**Model** : Finisher D1

**Ref. No.** : FF-T01-W-000053-01

**Subject** : Countermeasures to prevent the upper feeder assembly of the Finisher D1 from opening on impact

Fig. 1

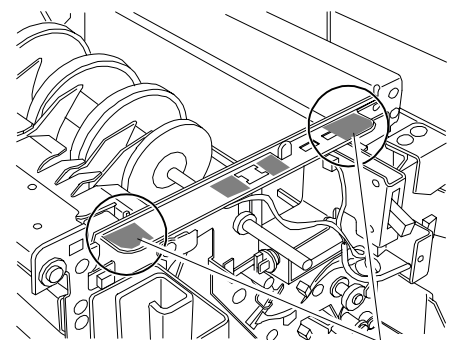
The upper feeder assembly is held to the plate at the front of the feeder assembly by 4 magnets, but the 2 magnets on the inner side float up due to poor molding procedure of the part into shape, and the cover opens due to insufficient magnet strength.

Because of some faults with the shape of the upper feeder assembly, two of the shaded areas (out of the four locations for the magnet catches) make contact first, causing a difference of approx. 0.25 to 0.5mm. This results in weaker contact for the other two areas, and the problem of upper feeder assembly to open from receiving an impact.

These areas make contact first.

A checklist at the source manufacturer for the upper cover has been expanded for rechecking of the mold finish and whether the shape is free from faults.

Fig. 2

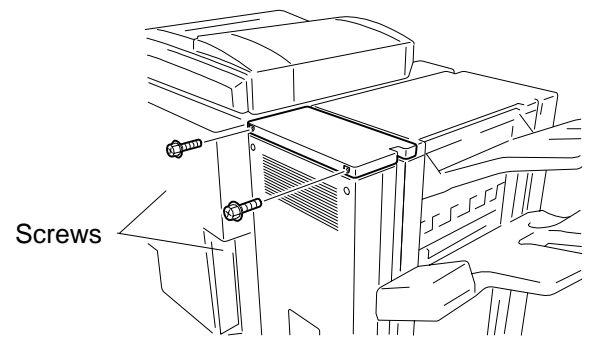
- 1) Remove the upper rear cover (2 screws).  
(Fig. 2)

Fig. 3

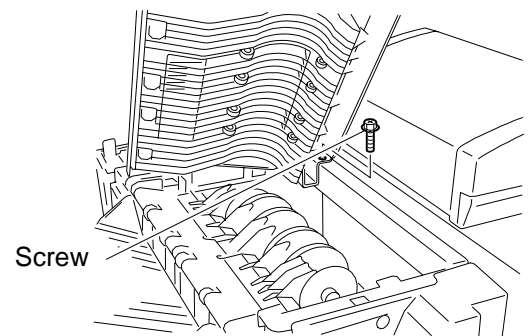
- 2) Open the front door.
- 3) Remove the upper feeder assembly.
  - a) Open the upper feeder assembly, and remove 1 screw from the inner side.  
(Fig. 3)

Fig. 4

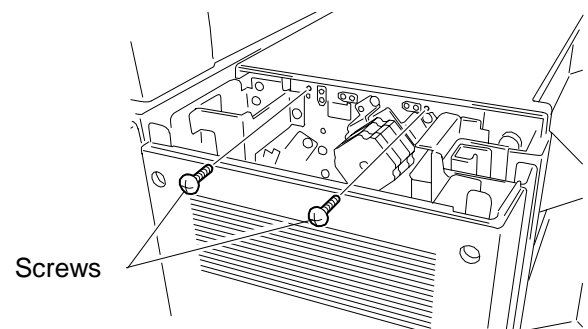
- b) Close the upper feeder assembly, and remove 2 screws from the rear side.  
(Fig. 4)

- 4) Replace the upper cover of the upper feeder assembly. (See Parts Catalog FY8-31E2-000 P.T35-1.)
- 5) Set the upper feeder assembly in place and secure it by tightening 2 screws at the rear.
- 6) Tighten 1 screw in the inner side of the upper feeder assembly.
- 7) Tighten the 2 upper rear cover screws.
- 8) Close the front door.
